Access Compliance Report Public Rights-of-Way (Curb Ramps)

Intersection ID: 15580 Main Street: ASHEVILLE PL **Cross Street: EAST BV** Location: NW ADA ID: F248F8EDFE8C Ramp Type: PerpDiag Initial Pass/Fail: Fail **Overall Compliance: No Severity Score:** 12.5

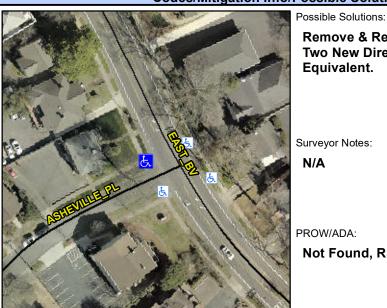
Not Found, R304.2.2

Field Measurements/Component Compliance					
Comp	liance Description	Data	Comp	liance Description	Data
N/A	Ramp Length (in)	79.0	No	Ramp Slope (%)	11.2
Yes	Ramp Width (in)	48.0	Yes	Ramp XSlope (%)	1.2
N/A	Flare Type LT	N/A	N/A	Flare Type RT	N/A
N/A	Flare Slope LT (%)	N/A	N/A	Flare Slope RT (%)	N/A
N/A	Flare Traversable LT?	N/A	N/A	Flare Traversable RT?	N/A
N/A	Landing Length (in)	N/A	N/A	DWS Provided?	N/A
N/A	Landing Width (in)	N/A	N/A	DWS Contrast?	N/A
N/A	Landing Slope (%)	N/A	N/A	DWS Length (in)	N/A
N/A	Landing X Slope (%)	N/A	N/A	DWS Full Width?	N/A
N/A	Landing Curb? (Y/N)	N/A	N/A	DWS Offset (in)	N/A
N/A	Shared Landing?	N/A			
N/A	Gutter Ponding?	N/A	N/A	Gutter Slope (%)	N/A
N/A	Gutter Lip Ht (in)	N/A	N/A	Gutter X Slope (%)	N/A
N/A	Painted X Walk1?	No	N/A	Painted X Walk2?	No
	X Walk 1 Direction	To SE		X Walk 2 Direction	To E
N/A	X Walk 1 Width (in)	N/A	N/A	X Walk 2 Width (in)	N/A
	X Walk 1 Slope (%)	0.2		X Walk 2 Slope (%)	2.5

Remove & Replace Curb Ramp With **Two New Directional Ramps or** Equivalent.
